QUALITY CONTROL REPORT

Independent Quality Control Report

Bell, Burnet, Coryell, Falls, Lampasas, and McLennan Counties Areas of Interest

HPIDS Project Number 580-11-1213
TWDB Task Order 19417169083

Figure 8 Void/gap check on the AOIs. Intensity image is overlaid onto a colored background (in this case yellow) to allow thorough identification of gross gaps and voids

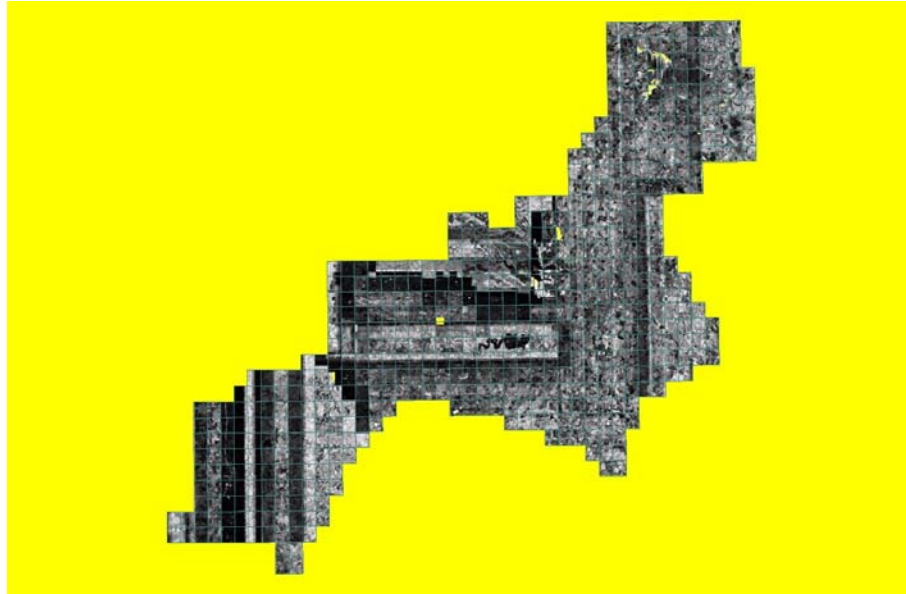
Figure 8 depicts a void/gap check conducted on both AOIs using LiDAR orthophotos generated in GeoCue. The imported .LAS files were used to create LiDAR “orthos.” The LiDAR orthos were one of the tools used to verify data coverage and point density, to check for gross data voids or gaps, and to use as reference data during checks for data anomalies and artifacts. These LiDAR orthos are not intended to be a project deliverable. The orthos were derived from the full point cloud elevations and LiDAR pulse return intensity values. The intensity values were used as delivered, with no normalization applied. Due to the point density of the original collection, the orthos were produced at a 1m pixel for the entire area of interest. Acceptable voids are those found over water features and some areas of dense vegetation. Any unacceptable voids identified by the void/gap check would be passed on to Photo Science and verified as corrected upon redelivery.
